Response to NRW Comments on Review of Cell 8 Basal Lining Design and CQA Plan

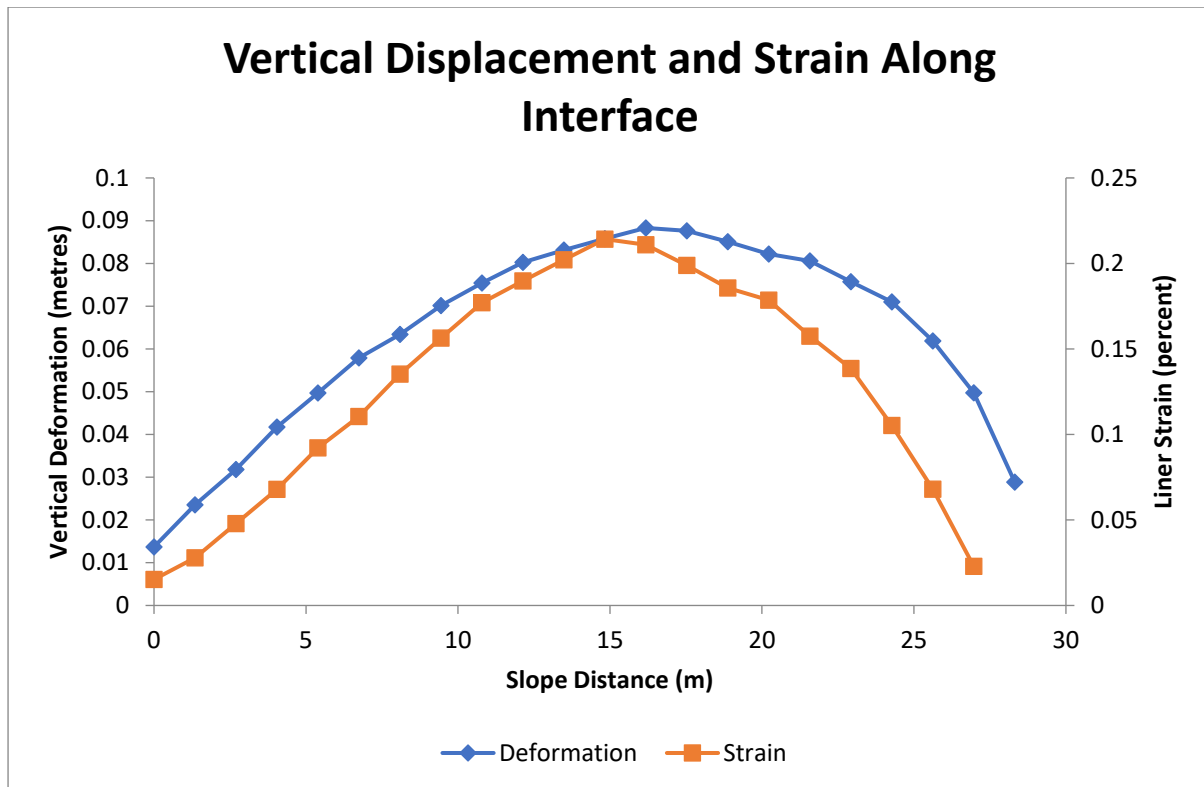
1. *What will be the final thicknesses of new waste deposited in the eastern piggy-back area over Cell 13? Is the increased loading significant enough to warrant modelling the extent of re-activation of settlement of the Cell 13 waste to investigate the degree of deformation of the Cell 13 capping membrane? The results of the modelling may require the use of a support layer, such as geogrid reinforcement.*

The final thickness of waste over the Cell 13 piggy-back will vary but is up to 13metres. The diagram below is a snapshot of the FE model made to examine this issue and it shows how the new wastes (pink) increase in thickness toward the edge of Cell 13 as the Cell 13 wastes decrease in thickness. The consequence of this loading event has been explored in a simple FE model, the results of which are shown on the graph beneath.

The graph plots the FE results along the interface between Cell 13 and Cell 8 to show how the current Cell 13 capping membrane and the proposed overlying Pozidrain drainage geocomposite will settle and stretch due to the imposed stresses caused by the overlying wastes. The output shows the displacement and also the strain in the plane of the liners.

The conclusion of the assessment is that the strain in the liner elements will be acceptably small (note that the in-plane strains are expressed as percentages not decimal fractions) without the need for geogrid reinforcement. This is the same approach that has been used on previous cells where new wastes have piggy-backed onto old wastes.
